Access Compliance Report

Public Rights-of-Way

(Curb Ramps)

Intersection ID: 28381	Main Street: HAWFIELD_WAY_DR	Cross Street: ARDREY_KELL_RD	Location: SE
ADA ID: 53CA199D4797	Ramp Type: BlendTrans1	Initial Pass/Fail: Fail	Overall Compliance: No
		Severity Score: 8.75

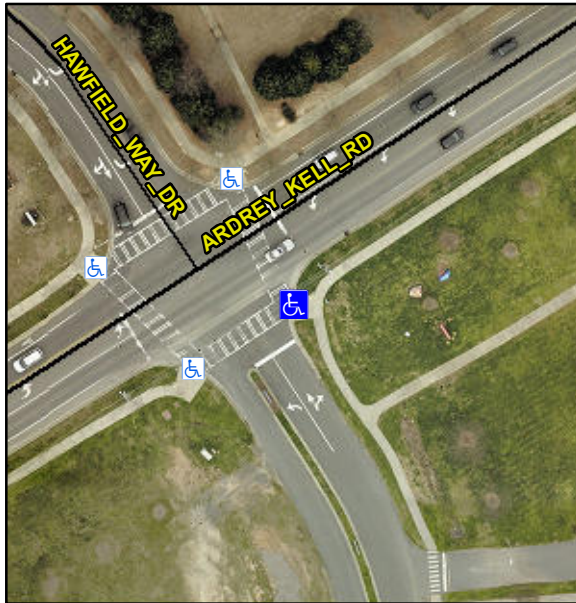
Not Found, R304.5.1

Compliance	Description	Data	Compliance	Description	Data
N/A	Ramp Length (in)	126.0	Yes	BlendTrans Slope (%)	3.8
No	Ramp Width (in)	46.5	Yes	BlendTrans XSlope (%)	1.6
N/A	Flare Type LT	N/A	N/A	Flare Type RT	N/A
N/A	Flare Slope LT (%)	N/A	N/A	Flare Slope RT (%)	N/A
N/A	Flare Traversable LT?	N/A	N/A	Flare Traversable RT?	N/A
N/A	Landing Length (in)	N/A	N/A	DWS Provided?	N/A
N/A	Landing Width (in)	N/A	N/A	DWS Contrast?	N/A
N/A	Landing Slope (%)	N/A	N/A	DWS Length (in)	N/A
N/A	Landing X Slope (%)	N/A	N/A	DWS Full Width?	N/A
N/A	Landing Curb? (Y/N)	N/A	N/A	DWS Offset (in)	N/A
N/A	Shared Landing?	N/A			
N/A	Gutter Ponding?	N/A	N/A	Gutter Slope (%)	N/A
N/A	Gutter Lip Ht (in)	N/A	N/A	Gutter X Slope (%)	N/A
N/A	Painted X Walk1?	Yes	N/A	Painted X Walk2?	Yes
	X Walk 1 Direction	To NW		X Walk 2 Direction	To SW
	X Walk 1 Width (in)	110.0		X Walk 2 Width (in)	111.0
	X Walk 1 Slope (%)	3.3		X Walk 2 Slope (%)	3.8
	X Walk 1 X Slope (%)	6.9		X Walk 2 X Slope (%)	4.1

N/A	Ramp inside XWalk1?	Yes	N/A	Ramp inside XWalk2?	Yes
	Road Slope (%)	2.0		Clear Space?	N/A
	Road X Slope (%)	7.3	N/A	Clear Space to XWalk (in)	N/A
N/A	Any Obstructions?	N/A	N/A	Storm Grate/Utility Hazard?	N/A
	Obstruction Type			Storm Grate/Utility Type	
		N/A			N/A
			Yes	Surface Condition? (G/P)	Good
			No	Curb Slope (%)	7.0

Remove & Replace Curb Ramp With Two New Directional Ramps or Equivalent.
